AQUALLIANCE

May 21, 2013

Subject: Comments on the Draft Environmental Assessment and Findings of No Significant Impact for the 2010-2011 Water Transfer Program

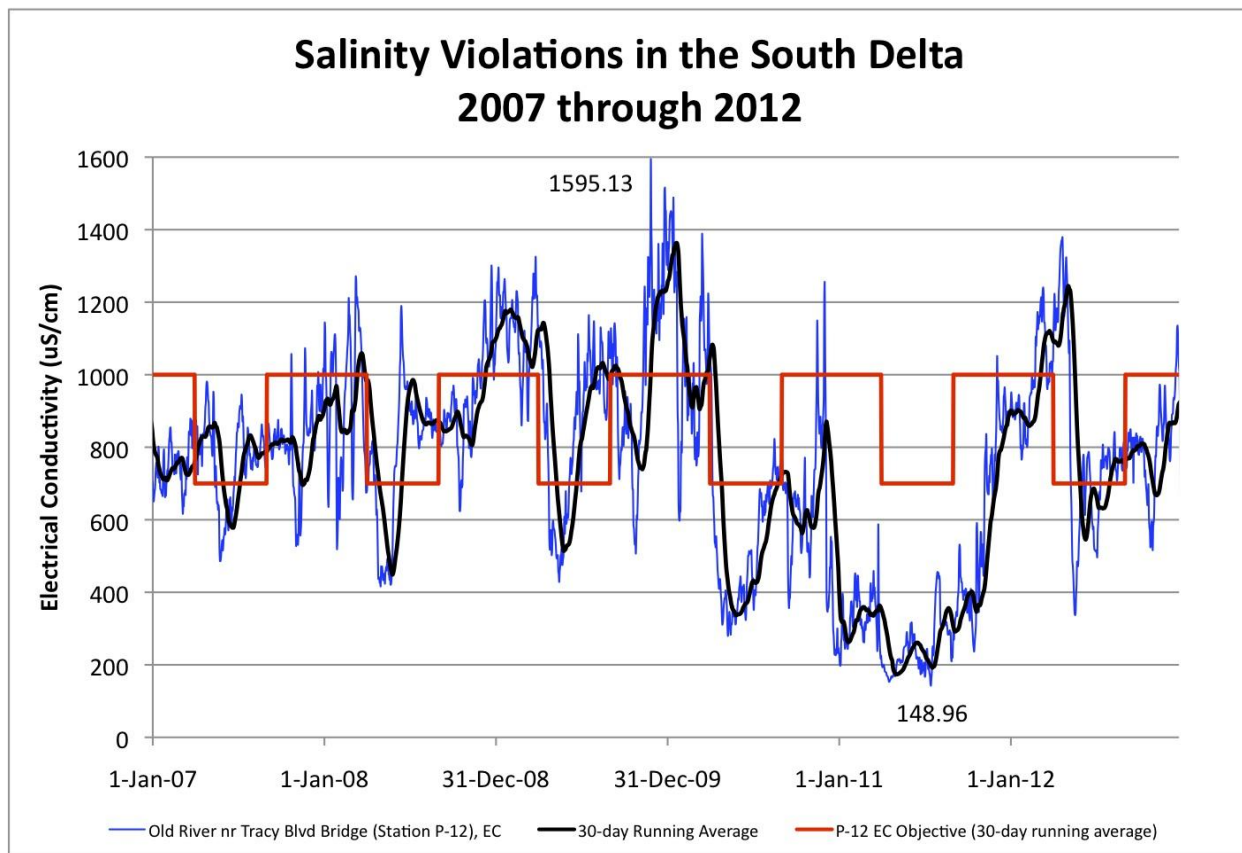
The *Draft Technical Information for Water Transfers* in 2013 continues with suggestions to curtail pumping from lower bowls, and pay higher energy costs to ease the impacts to third party wells owners (p. 38-39). While this bone thrown at mitigation is appreciated, the glaring omissions are notable. The *Draft Technical Information for Water Transfers* in 2013 completely fails to mention, even at a very general level, how individual well owners who may be harmed by the Project, will determine and prove where the impacts to their wells are coming from, that water quality and health could become a significant impact for impacted wells, users, and streams. The onus for coping with and disclosing potential impacts is deflected onto the nonparticipating public, species, and environment. How does this meet the requirements of NEPA and CEQA? Since wetlands and streams would require human observation or adequate monitoring to report an impact, how will, “Affecting the hydrologic regime of wetlands or streams to the extent that ecological health is impaired,” be avoided or mitigated without standards and requirements from the Bureau and DWR? (*Draft Technical Information for Water Transfers* p. 38) There also appears to be no consideration for species monitoring, just “practices” or “conservation measures” to “minimize impacts to terrestrial wildlife and waterfowl,” (*Draft Technical Information for Water Transfers* pp. 16, 20, 22-24).

The EA/FONSI and the *Draft Technical Information for Water Transfers* in 2013 don’t appear to weigh the significance of avoidance of impacts, pre-Project mitigation, during Project mitigation, or post-Project mitigation. This fails to create objective standards and merely differs responsibility to the “willing sellers,” a broadly unsuspecting public, and a voiceless environment.

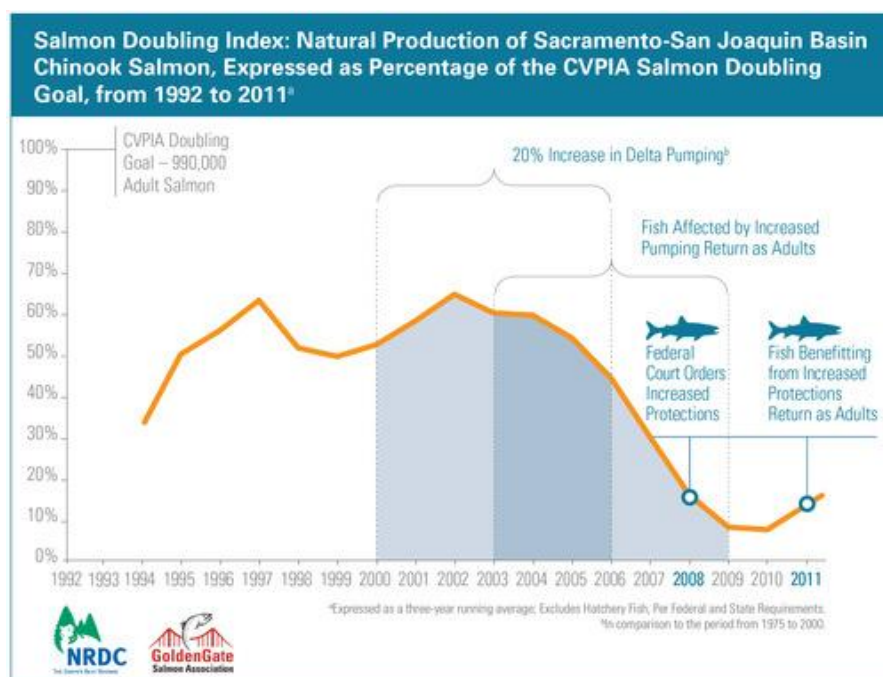
The draft EA acknowledges the potential for impacts to special status fish species from altered river flows and commits to maintaining flow and temperature requirements already in place (p. 12). AquAlliance would like to have greater assurance of a commitment considering, as noted above, that the Bureau and DWR fail to meet the X2 standard in the Delta regularly and repeatedly. The Bureau and DWR should make X2 compliance and streams of interest monitoring in real time part of their permit amendment applications to the SWRCB in June 2013. If stream levels are affected by groundwater pumping, then pumping would cease.

Unfortunately, the draft EA fails to anticipate possible stream flow declines in important salmon rearing habitat in the 2013 Water Transfer Program area. Many important streams, such as Mud Creek, are located within the 2013 Water Transfer Program and flows through probable Tuscan recharge zones, yet are not mentioned in the EA (also see comments above regarding Rock Creek). While a charged aquifer is likely to add to base flow of this stream, a de-watered aquifer would pull water from the stream. According to research conducted by Dr. Paul Maslin, Mud Creek provides advantageous rearing habitat for out-migrating Chinook salmon (1996). Salmon fry feeding in Mud Creek grew at over twice the rate by length as did fry feeding in the main stem of the Sacramento River. *Id.*
